District Office- Tenant Improvement

981 Ridder Park Drive, San Jose, CA 95131
MDG Project # 2203

MECHANICAL UPGRADES – BID #B-03-2022-23
ELECTRICAL UPGRADES – BID #B-04-2022-23
GENERAL CONSTRUCTION – BID #B-05-2022-23

October 21, 2022

ENLARGED FLOOR PLANS &
INTERIOR ELEVATIONS
RESTROOMS

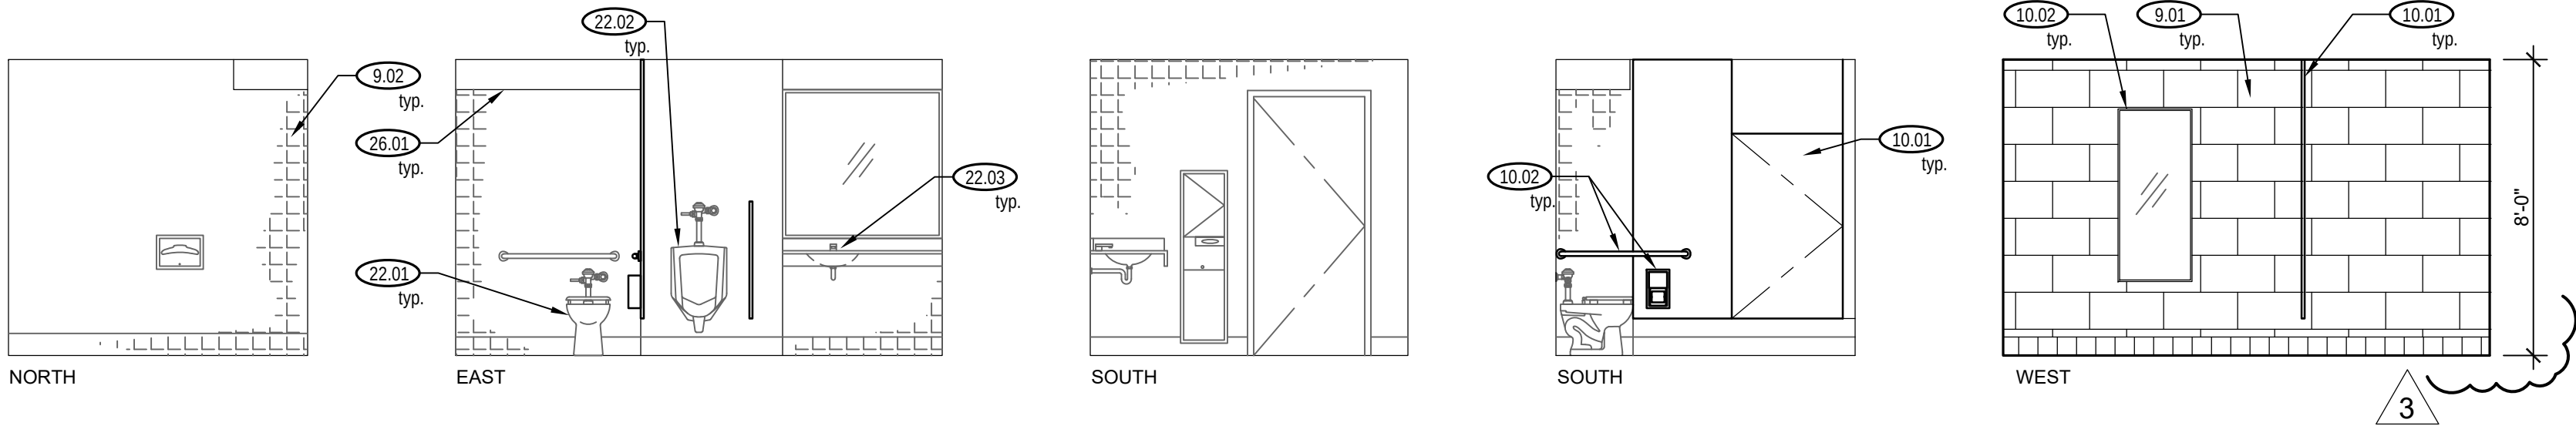
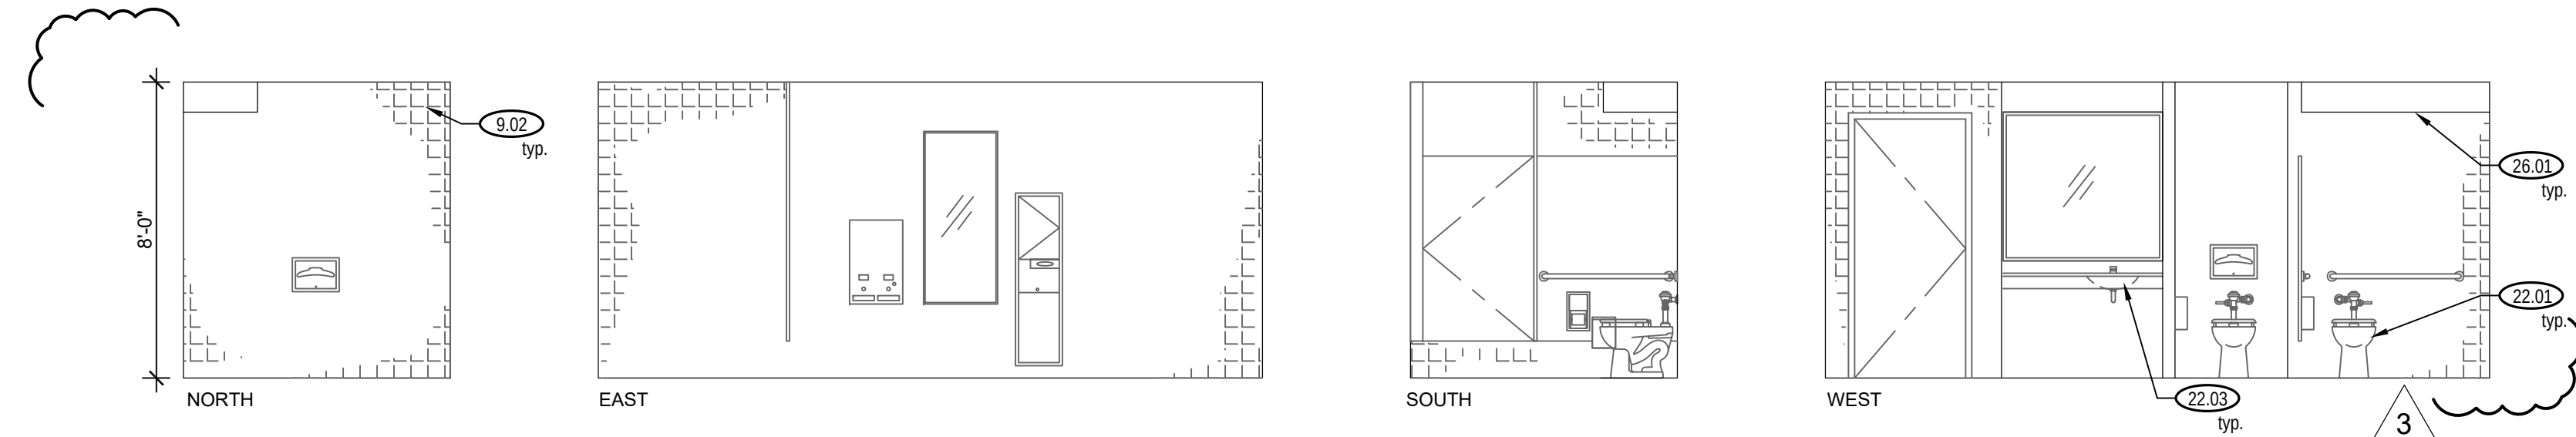
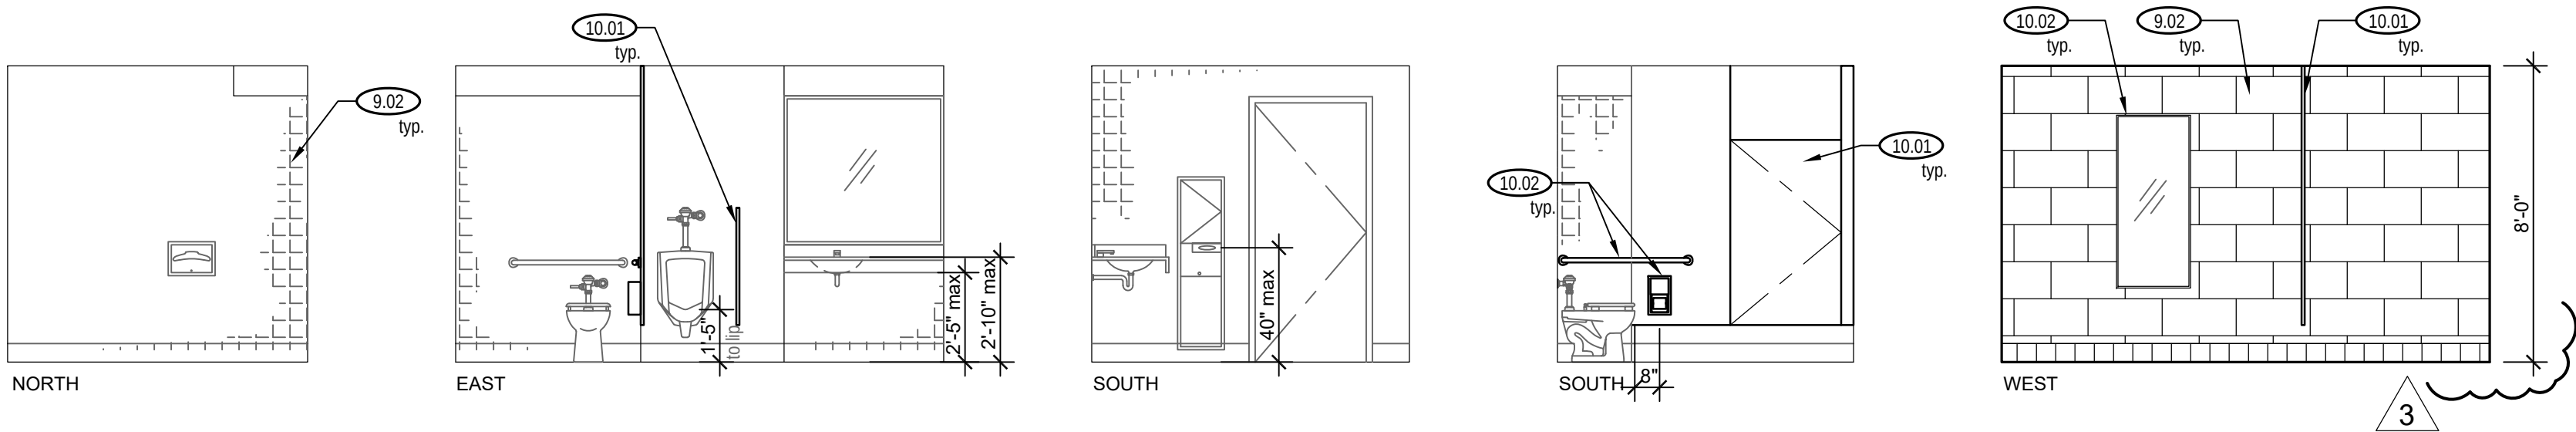
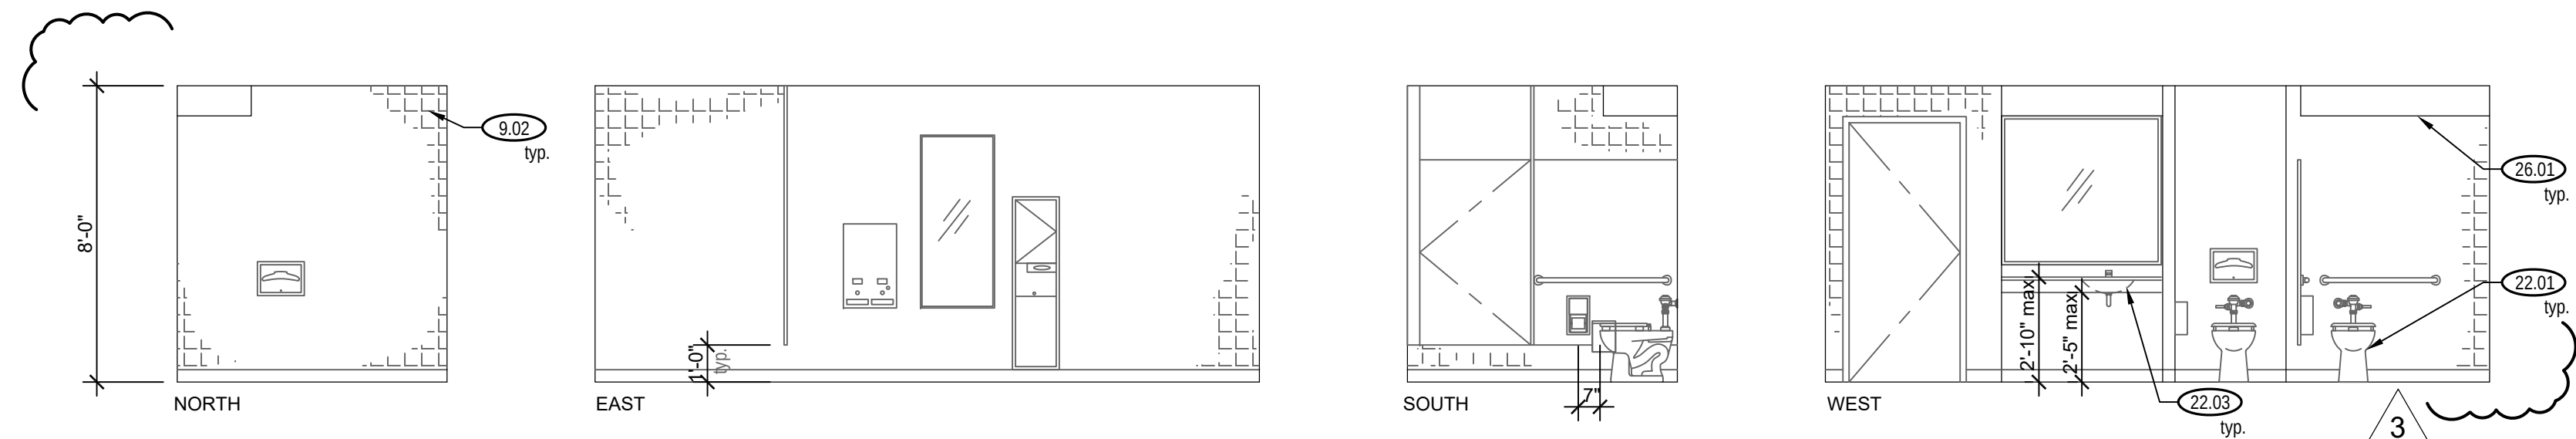
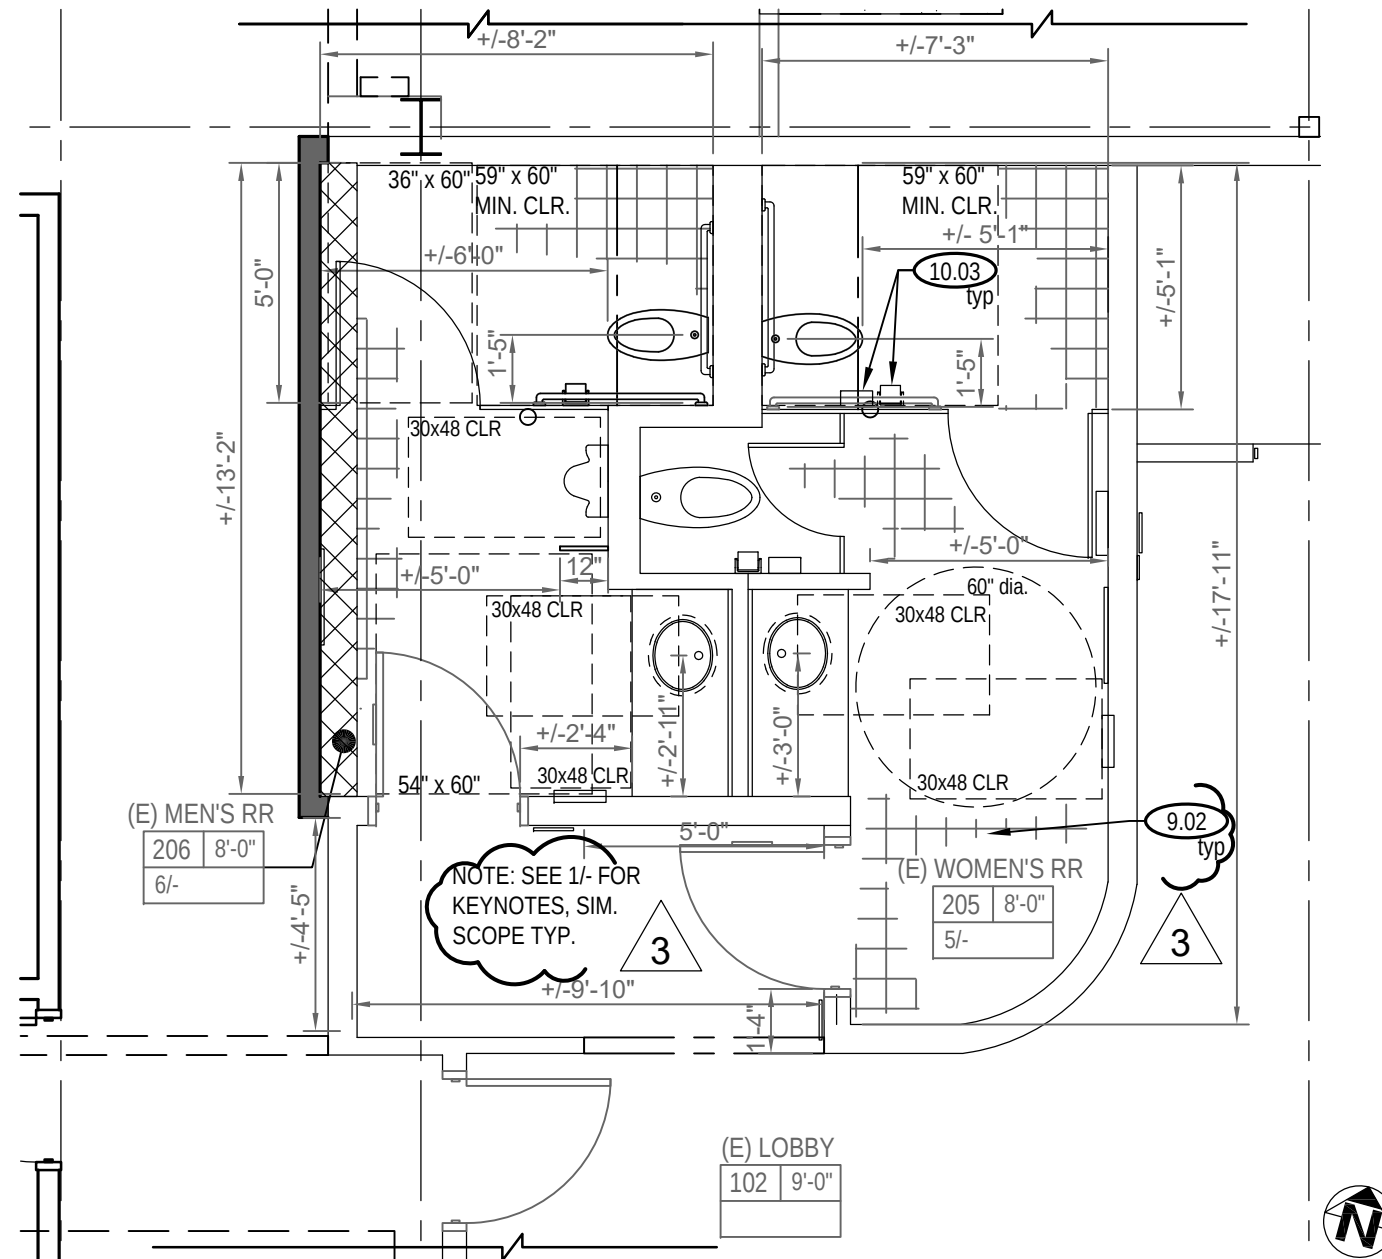
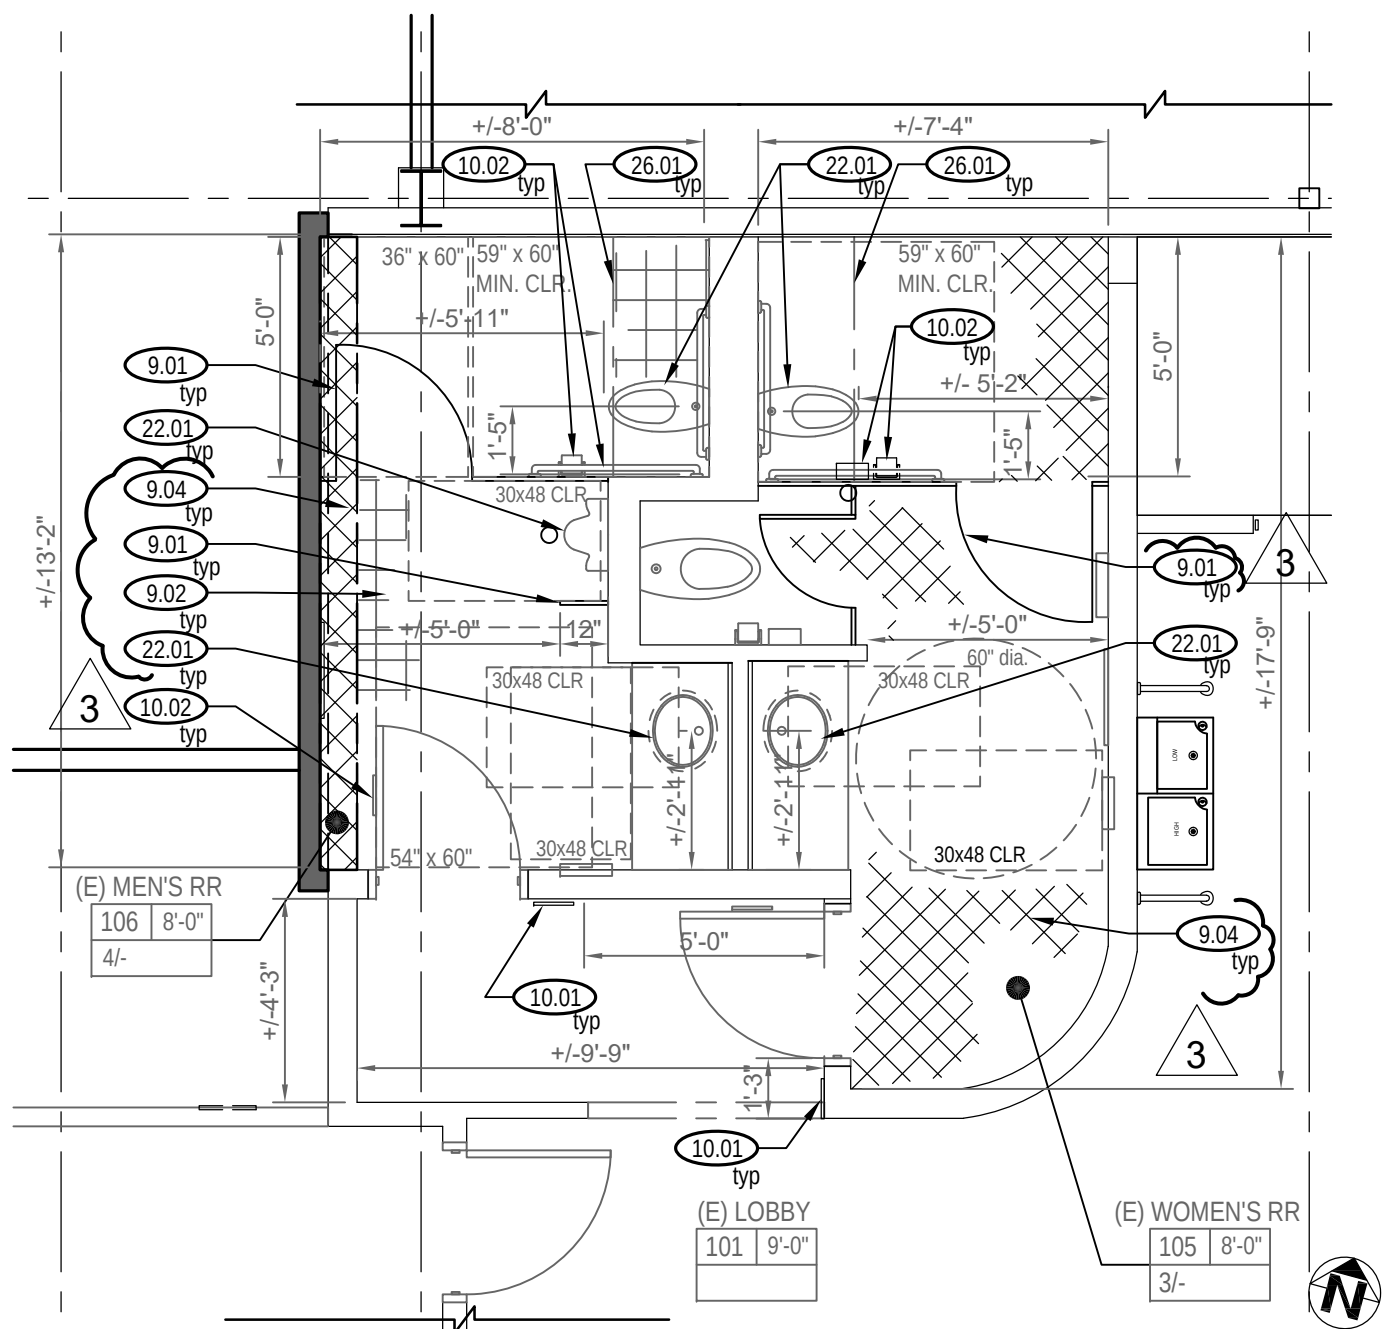
Item 12: Sheet 9.2 Enlarged Restroom Floor Plans & Interior Elevations

- A. Provide new solid phenolic toilet partitions and urinal partitions at Women's 105, Men's 106 and Men's 206 per revised keynote 9.01.
- B. Provide new metal stud wall to meet accessibility per plans at Men's 106 and Men's 206.
- C. Provide ceramic tile floor patch at Men's 106 and Men's 206 per revised keynote 9.04
- D. Revised keynote 10.02 to read 22.01 at Men's 106.
- E. Provide new ceramic tile flooring in Women's 105.
- F. See revised interior elevations 3, 4, 5, 6/ A-9.2 and associated keynotes which reflect floor plan changes.
